H2Teesside Project

The H2 Teesside Order

Document Reference: 8.4: Applicant's Comments on Relevant Representations and Additional Submissions

Date: September 2024

Figure 1: Updated airborne sound modelling locations

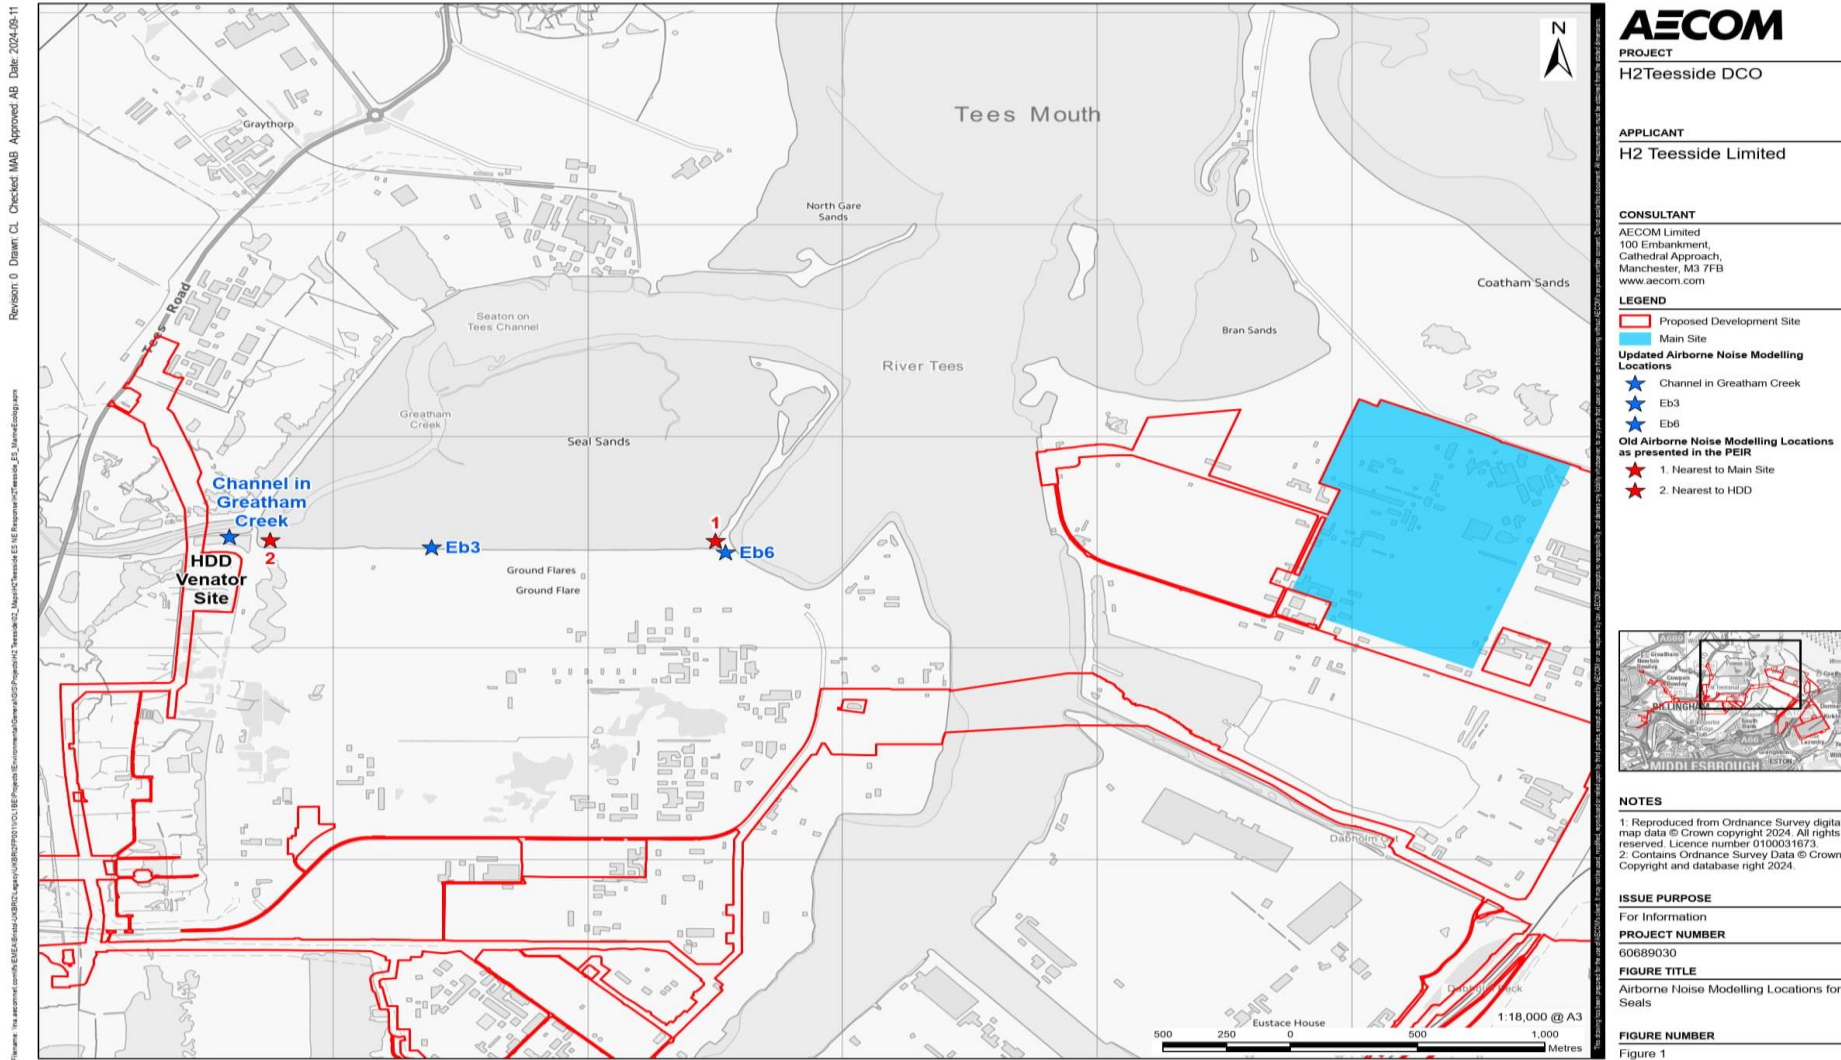
- 2.1.1 Natural England have raised concerns regarding the potential for a barrier effect to seals moving between Greatham Creek and Seal Sands, due to noise produced by HDD 4 at the Venator Site. During the baseline monitoring for the Environmental Statement (ES), noise values were provided for location 1 and location 2, shown on Figure 1 below.

- 2.1.2 However, to further assess the effect of airborne noise, an additional noise modelling location has been added, which is positioned at the mouth of Greatham Creek channel, closer to the potential location of seals (Figure 1).

- 2.1.3 Through a review of the noise modelling conducted for the ES, it was determined that the airborne noise modelling 'location 2', as presented in Figure 14-7 in Chapter 14: Marine Ecology of the ES, and shown on Figure 1, was not the most appropriate location, compared to where the noise modelling had actually been conducted (based on the locations of the baseline noise surveys). The updated location 2, now referred to as Eb3, is presented in Figure 1, which shows a comparison between these two locations. Location 1 has remained in a similar position and is now referred to as Eb6 (Figure 1). Due to the changes in locations, there have been minor updates to the predicted sound levels used for the assessment of the proposed construction and operation activities and these have been reflected in our calculations.

- 2.1.5 The updated noise predictions based on the updated modelling locations are provided in Table 1.
